City of Beaumont Wastewater Treatment Plant Salt Mitigation Upgrade Project Change Order No. 15

April 14, 2020

Contractor: W.M. Lyles Co.	Original Contract: \$ 53,312,000.00	Calendar Days: 820	Comp. Date: 1/26/2021
Project Name: Wastewater Treatment Plant Salt Mitigation Upgrade Project	Previous Approved Changes: \$1,640,717.91	95	5/1/2021
Contract No.: C18-80	This Change: Amount \$79,713.39	0	
CO Number: 15	Revised Contract: \$55,032,431.30	915	5/1/2021
	Previous Phase 1 Completion Date		4/26/2020
	Revised Phase 1 Completion Date		4/26/2020

SHEET
MBM-22

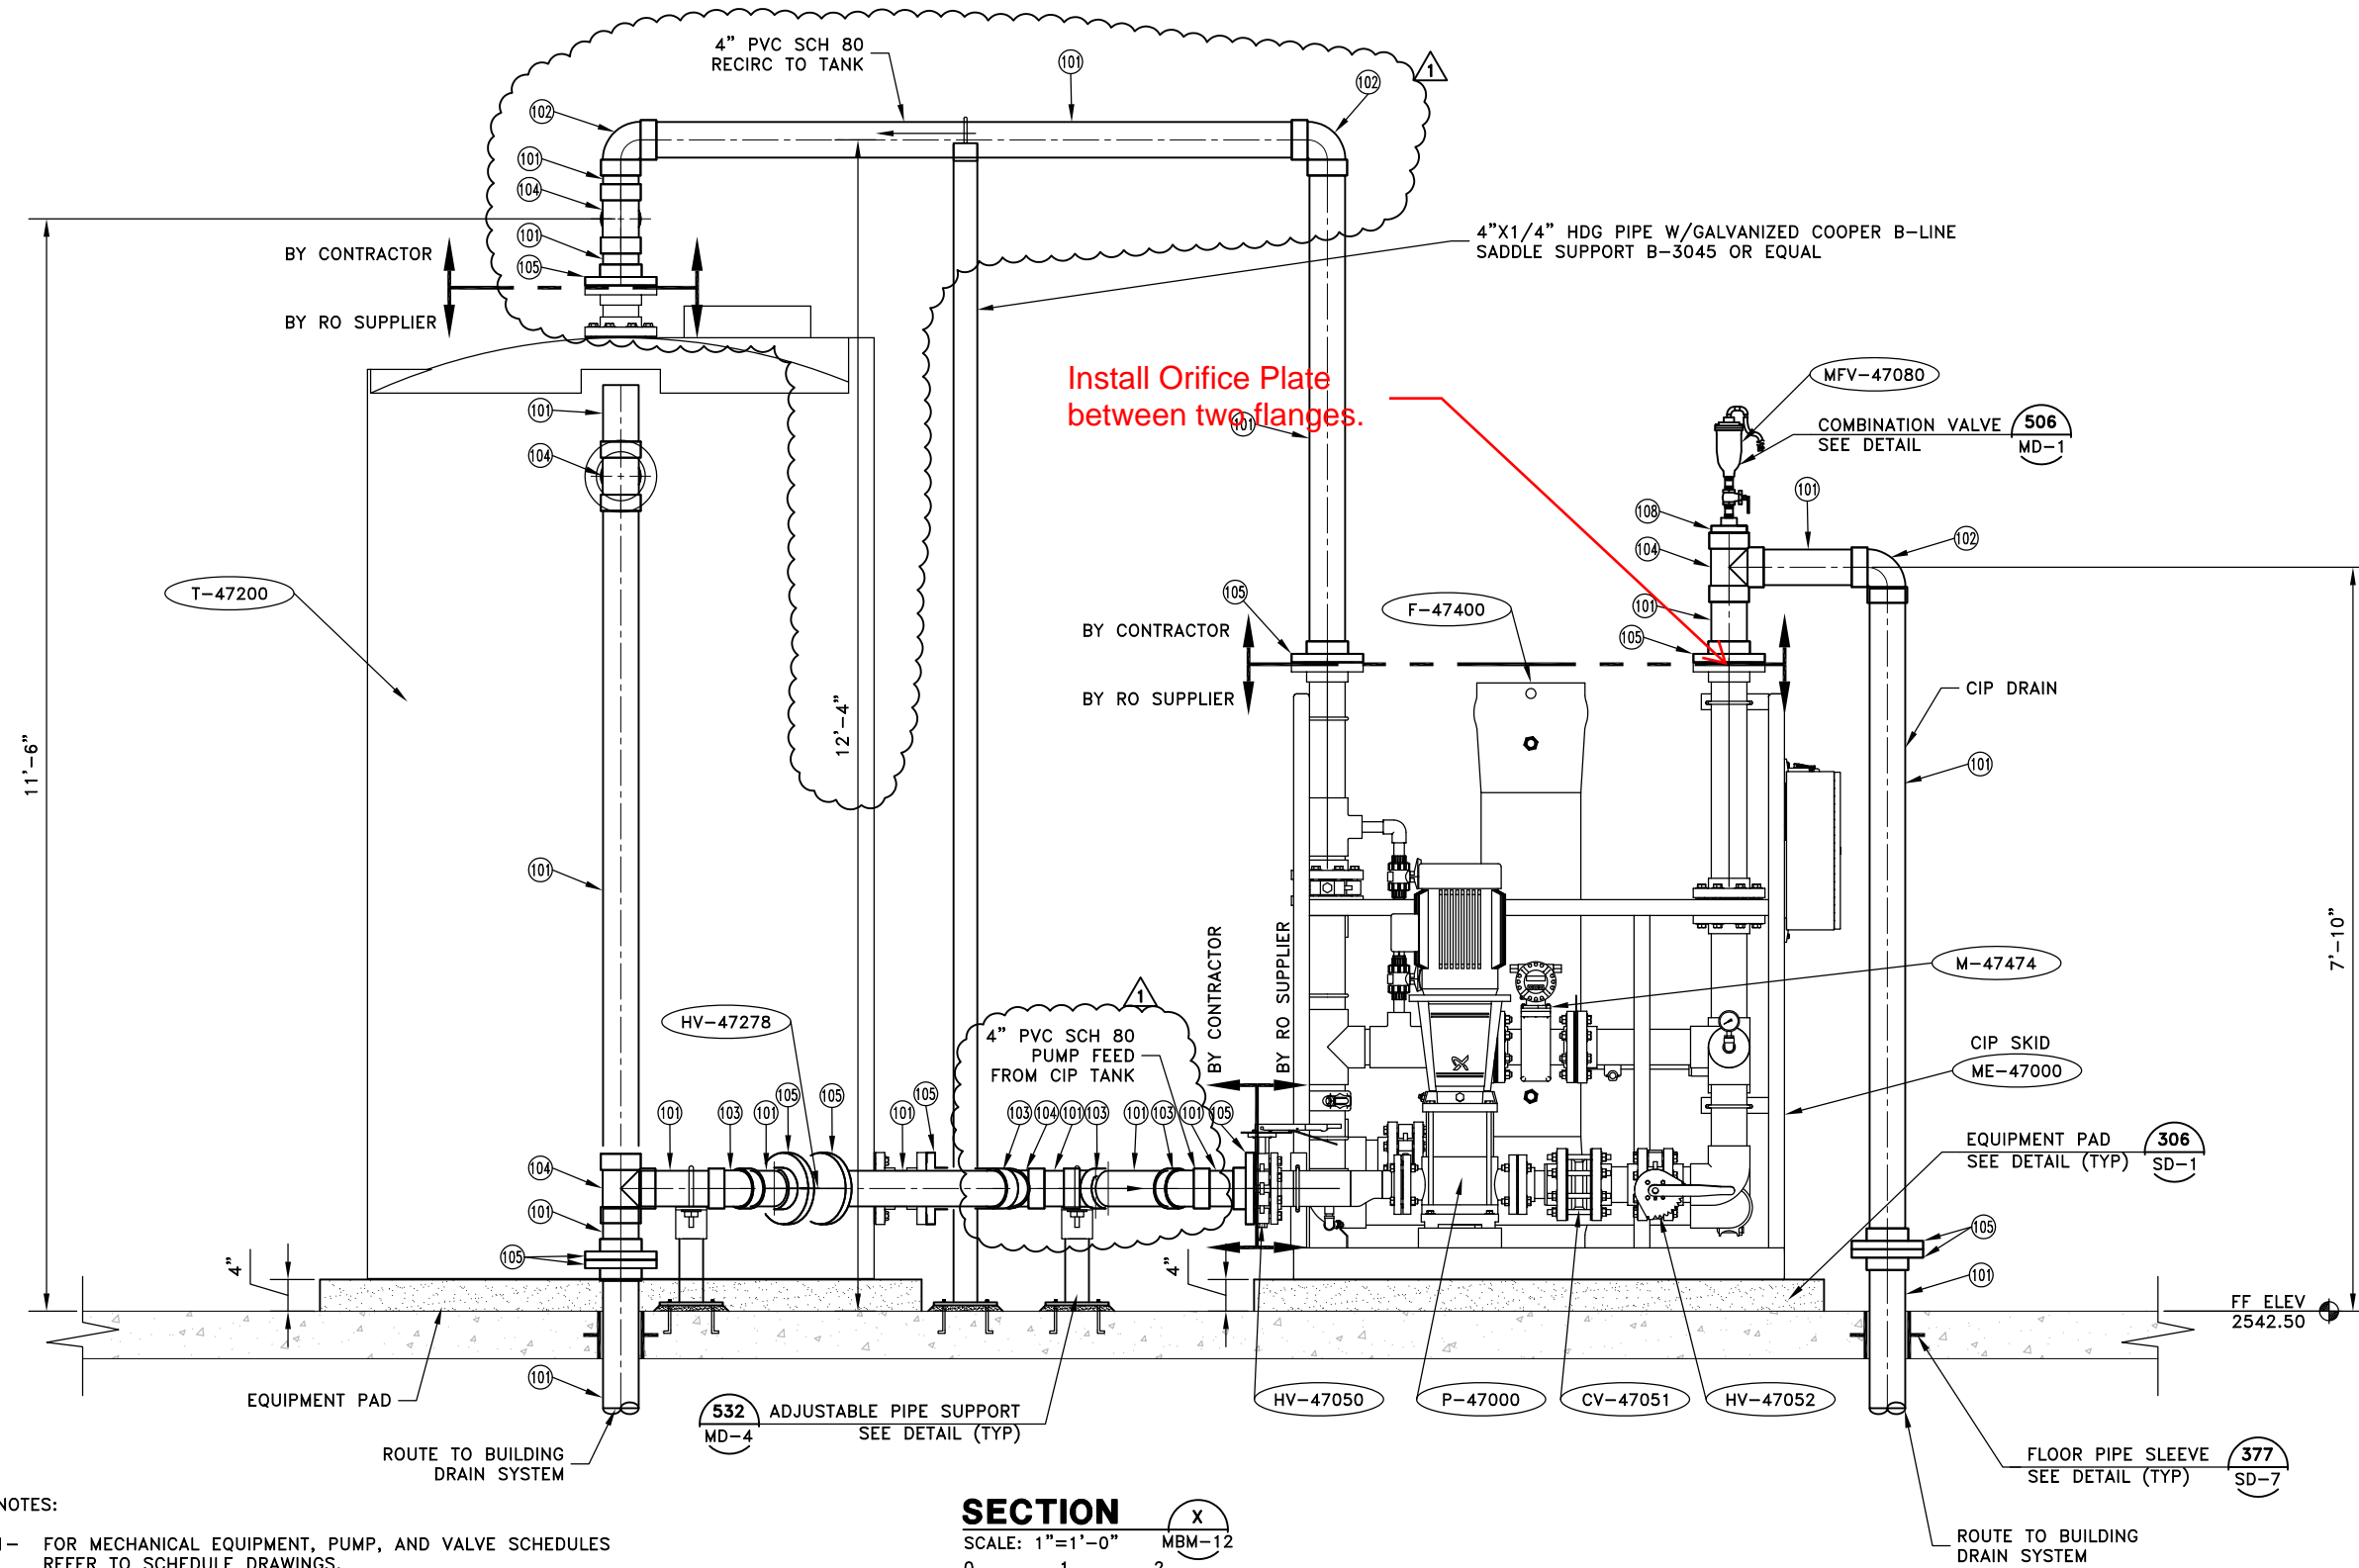
PCO-36	
Design Adjustment: WML COP-040.1	RO CIP Skid Discharge Orifice Plate
<p><u>Reason for Design Changes:</u></p> <p>Design Engineer Initiated Change: The RO CIP Skid supplied by H2O Innovations is used to clean the RO membranes prolonging the life of the membranes. The pump which boost the pressure to the membranes along with being used to recirculate and mix the cleaning solution is also used to pump spent cleaning solution to waste. When used to waste cleaning solution a flow restriction plate is required to maintain back-pressure on the pump. The design engineer and equipment manufacturer have reviewed the pump curves and sized an orifice plate to meet the design curve conditions for this pumping condition.</p> <p><u>Design and Scope Changes:</u></p> <ul style="list-style-type: none"> • W.M. Lyles shall procure and install an orifice plate pre-engineered by H2O Innovation and Aqua Engineering on the CIP skid discharge to waste piping system. Orifice plate shall be installed at the location shown on the revised drawing attached. • Cost proposal shall also include the cost for new gaskets and longer bolt hardware kit. <p><u>Cost Impact:</u></p> <p>Design Engineer Aqua Engineering and equipment manufacturer H2O Innovation has previously negotiated the material costs of the orifice plate. MWHC has reviewed the contractor's 1st cost proposal requesting \$1,854.54 to perform the work. After review and negotiation, WML COP-040 was revised for a contract cost increase of \$1,183.92. MWHC recommends a contract cost increase to be executed in a change order for the sum of \$1,183.92.</p>
